Subject: Oyster Creek Nuclear Generating Station
Docket 50-219
Sea Turtle Incidental Capture Report 98-1

Oyster Creek Nuclear Generating Station

GPUN Responses to Request for Additional Information and Revisions Regarding Biological Assessment of Sea Turtles

Figure 3-2. Location map of OCNGS and vicinity.

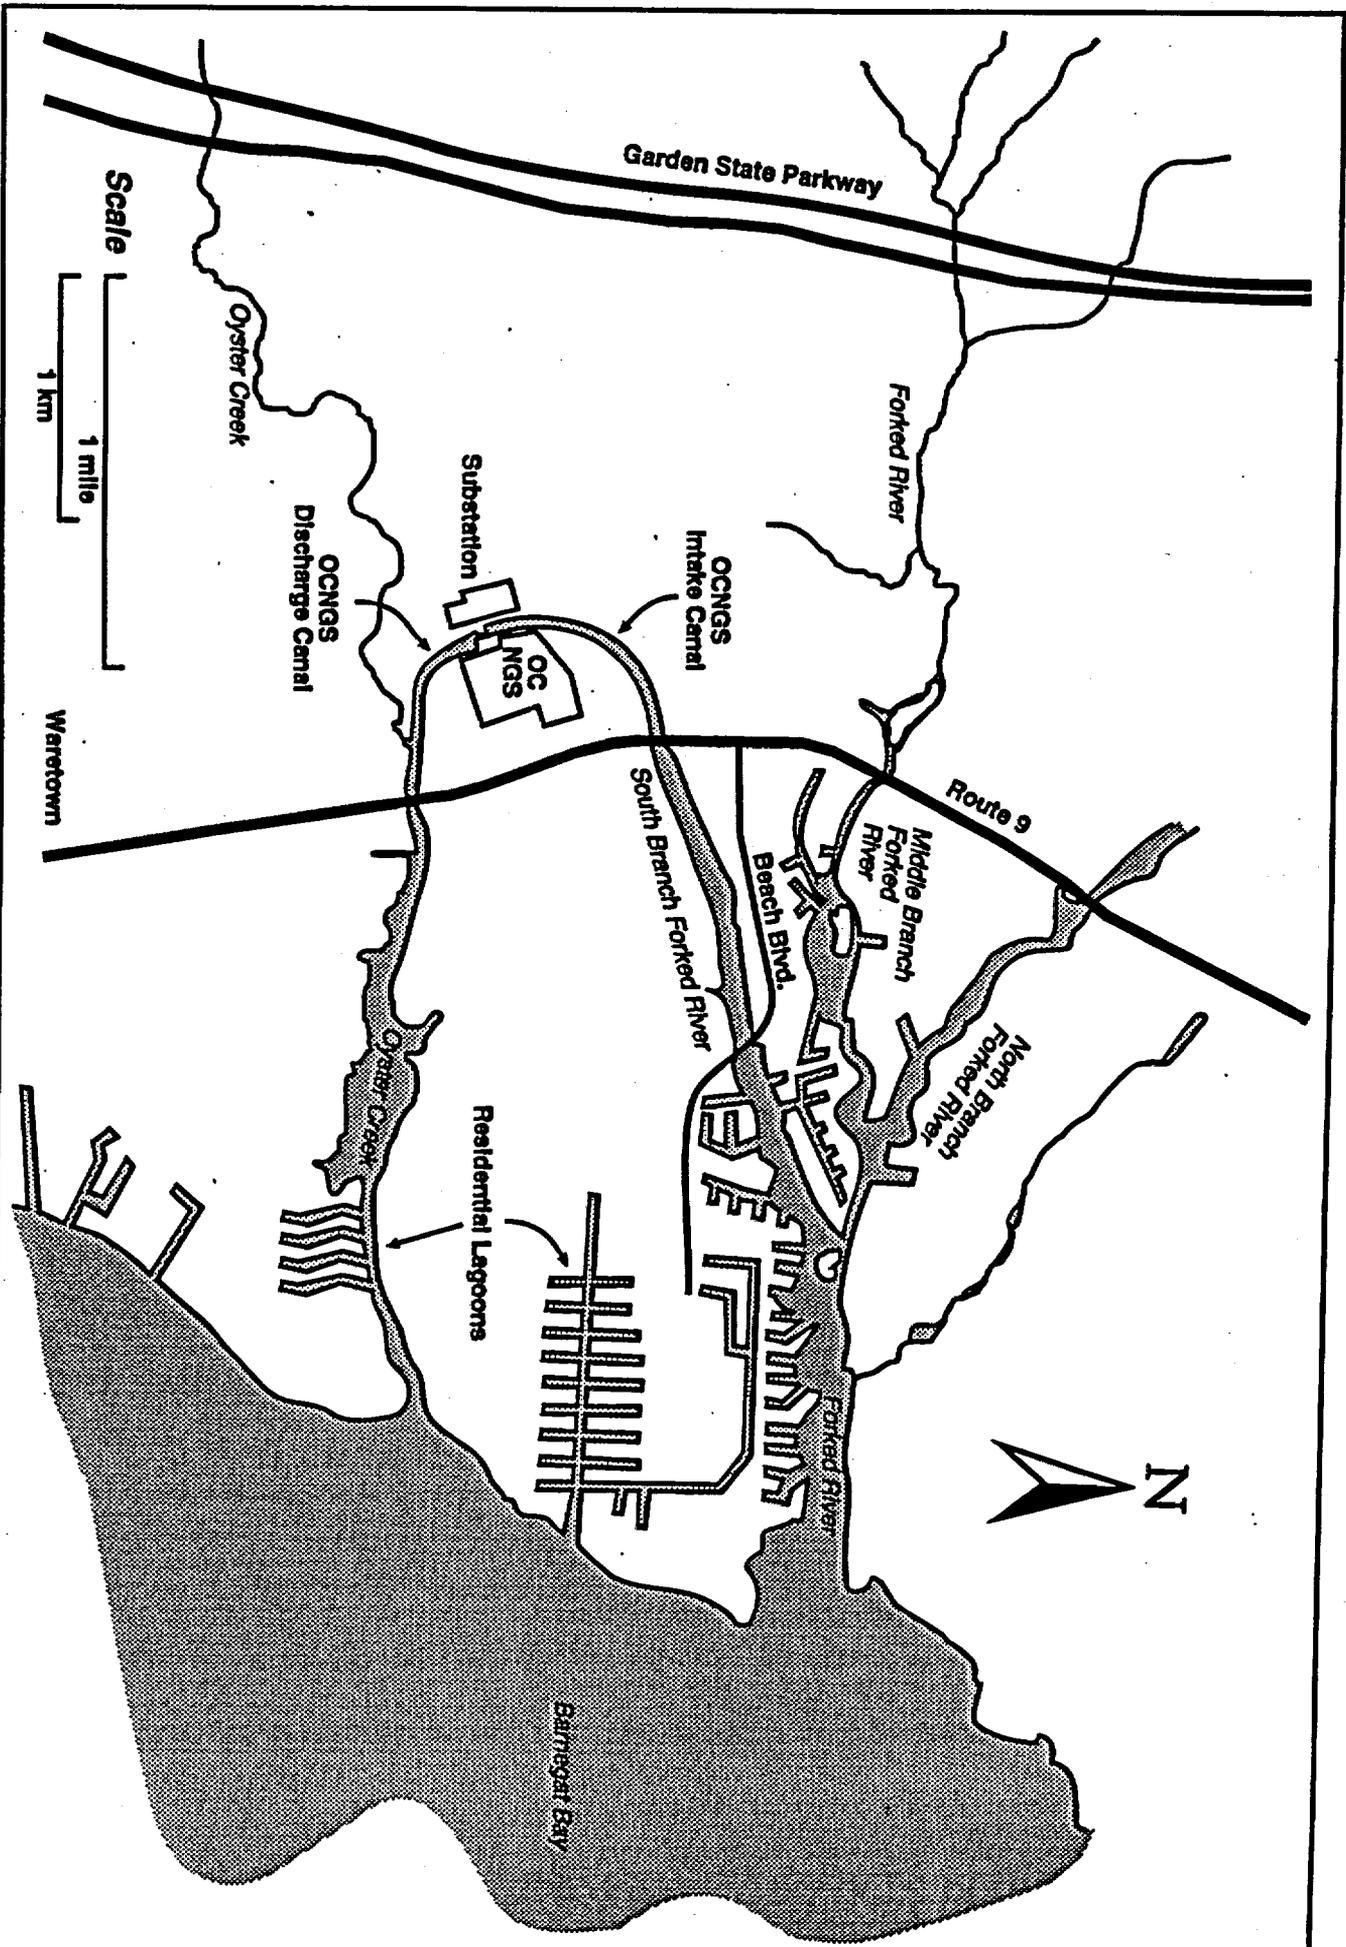
2. Figure 3-2 is very difficult to understand. A better schematic is needed.

RESPONSE: A better schematic is being developed and will be included in the revised Biological Assessment.

Figure 4-3. OCNCS Circulating System Intake Structure, section view.

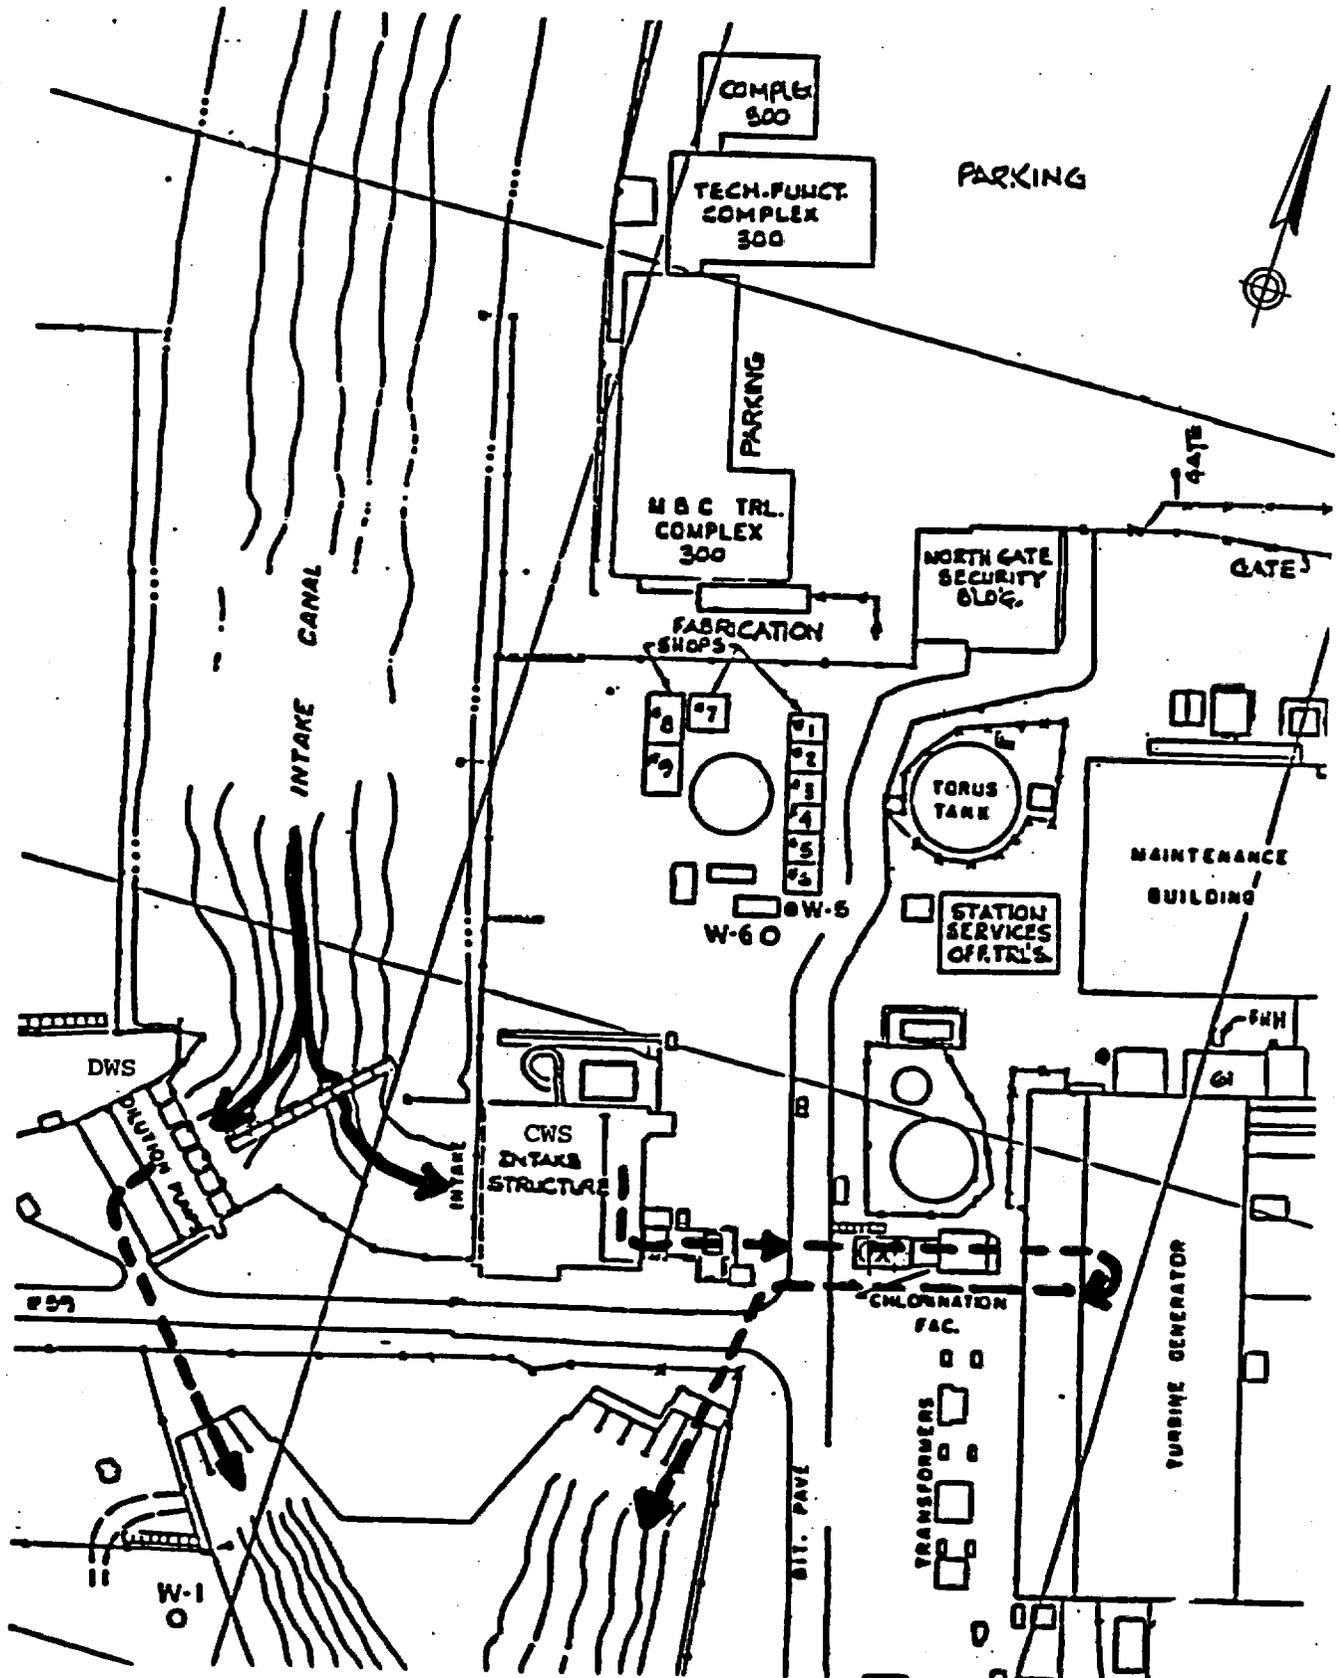
5. Page 4-4, section 4.1.2. Expand the dilution pump explanation. This is an unusual system unlike any other nuclear plant. Provide an explanation of the operating schedule and explain when the dilution pumps are used. Provide a better drawing than Figure 4-5, more along the lines of Figures 4-3 and 4-4. Include a better line drawing of the trash bars.

Improved drawings of the dilution pumps and trash bars are being developed and will be included in the revised Biological Assessment.

Figure 4-6. OCNGS Dilution Water System Intake Structure, Section View.

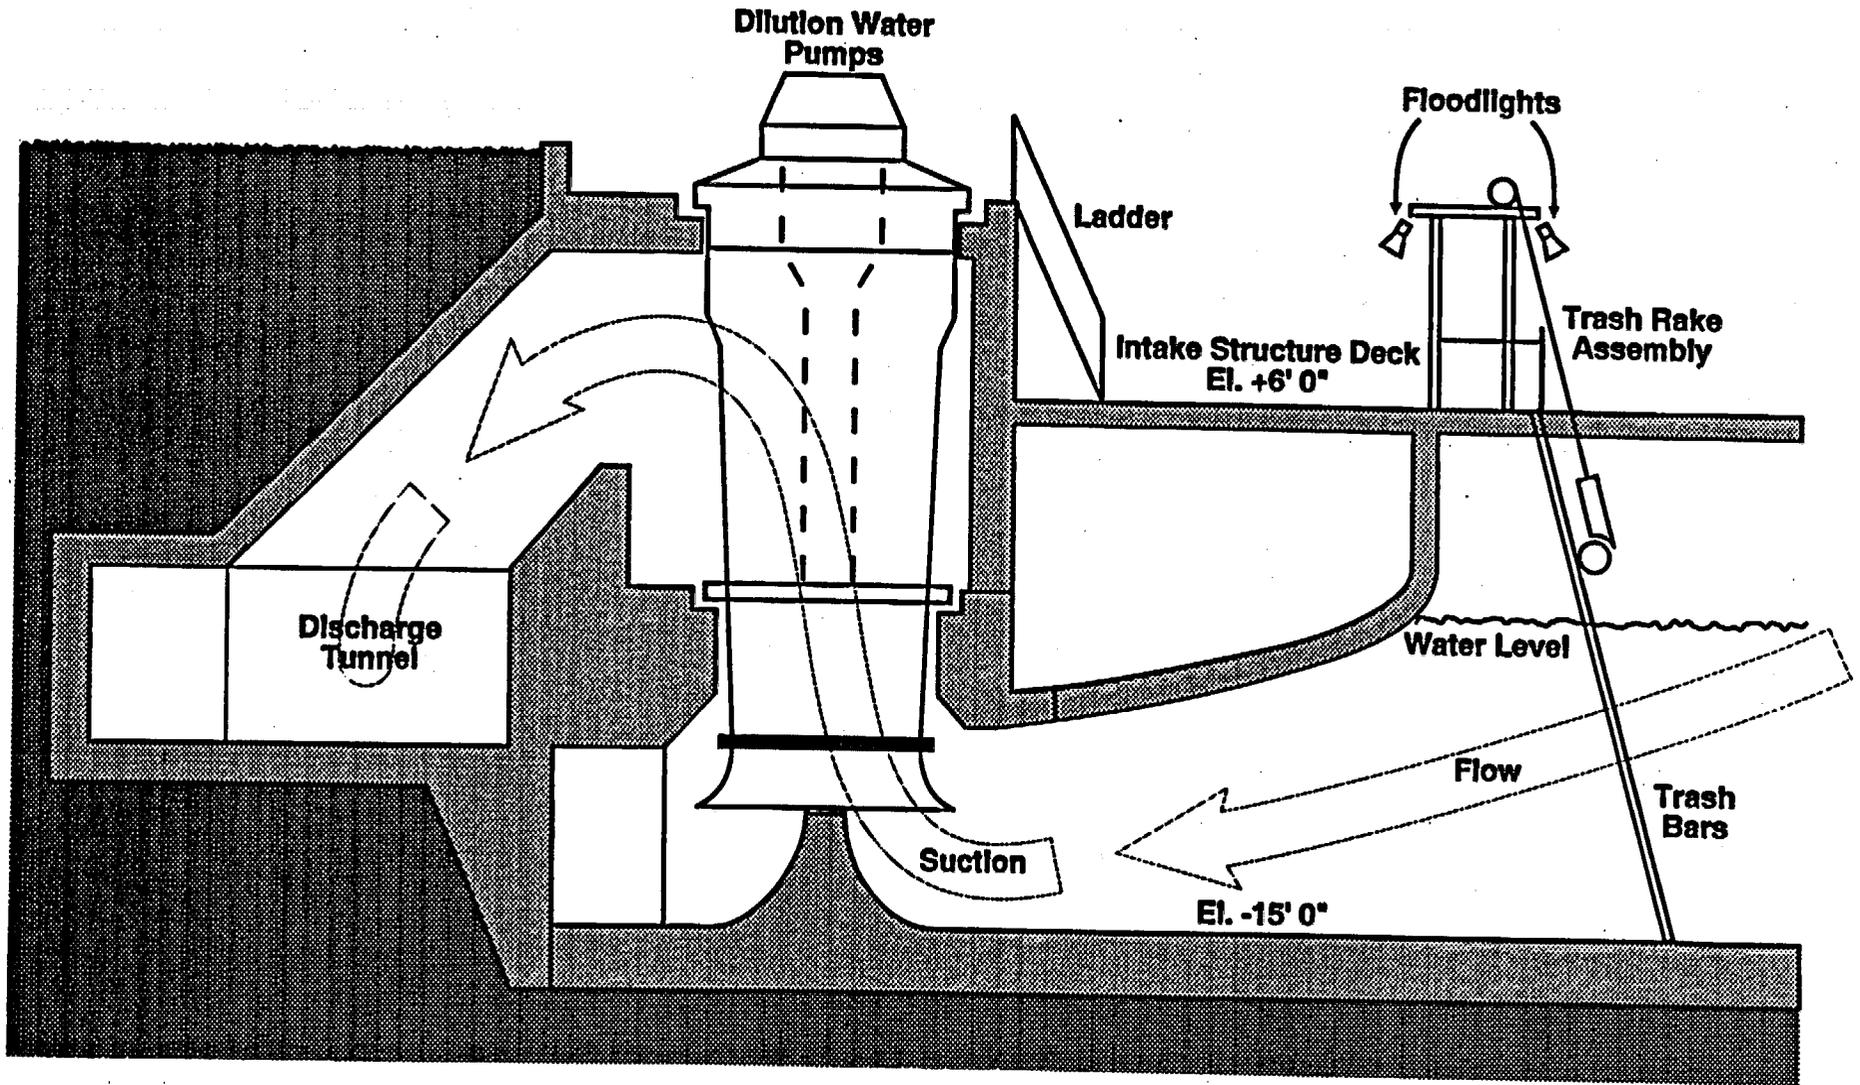
6. Figures 4-6 and 4-7 are not applicable and can be deleted.

RESPONSE: These figures will be deleted.

Figure 5-1. Generalized sea turtle life cycle (After PSE&G 1989).

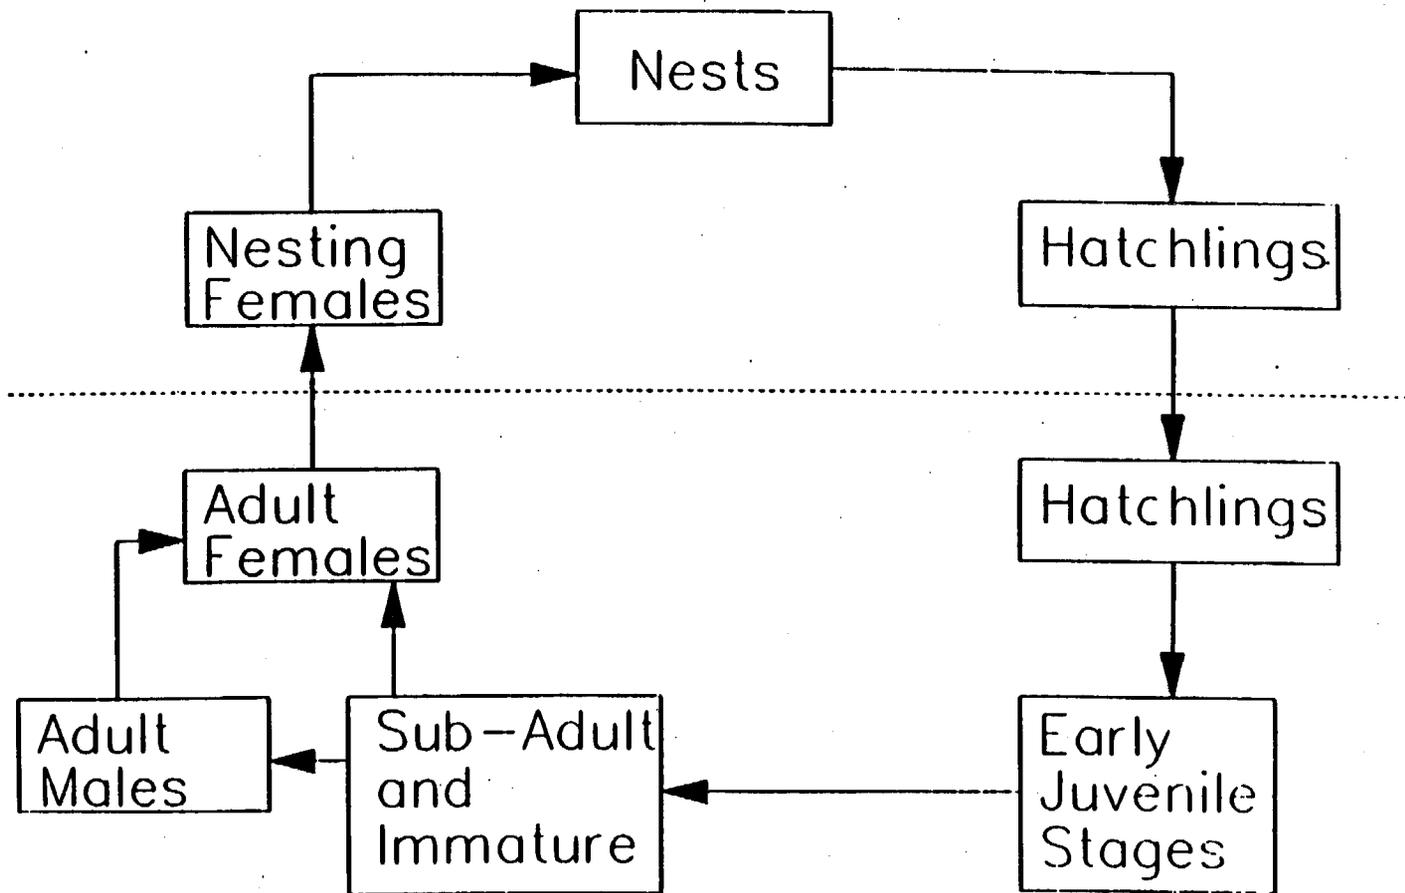
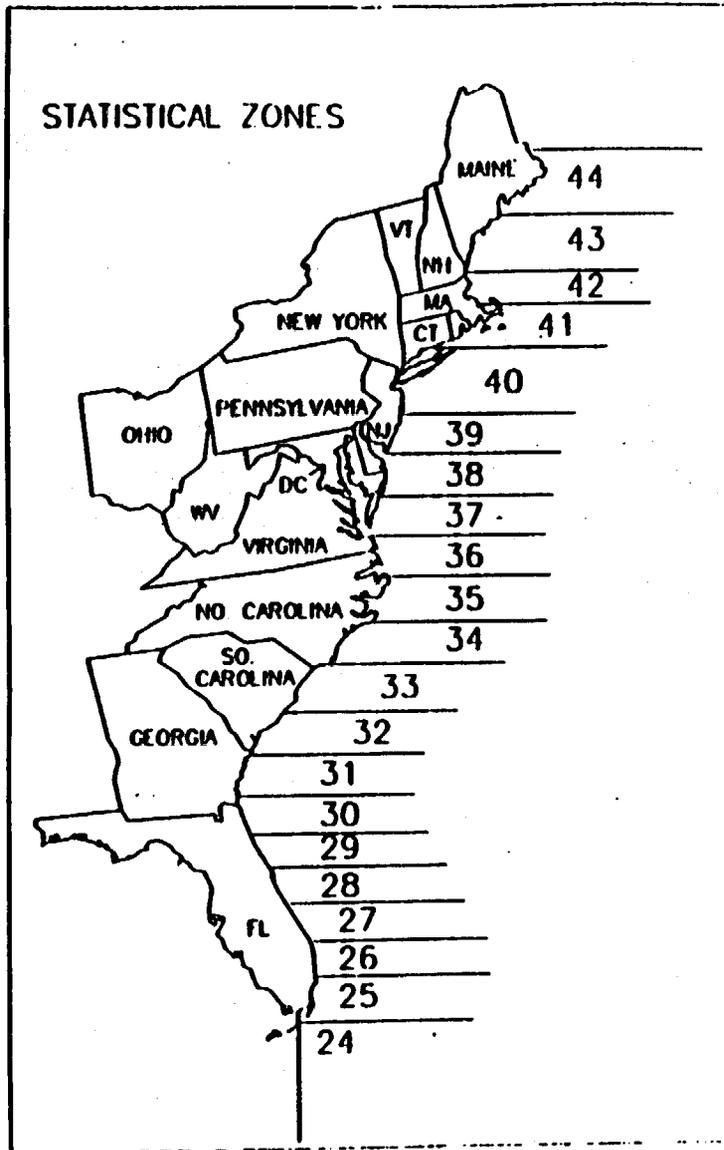
9. Figure 5-1, Is there stranding data for 1993? If so, provide this information (by county, if available).

RESPONSE: GPUN is attempting to obtain this information and will include whatever is available in the revised Biological Assessment.
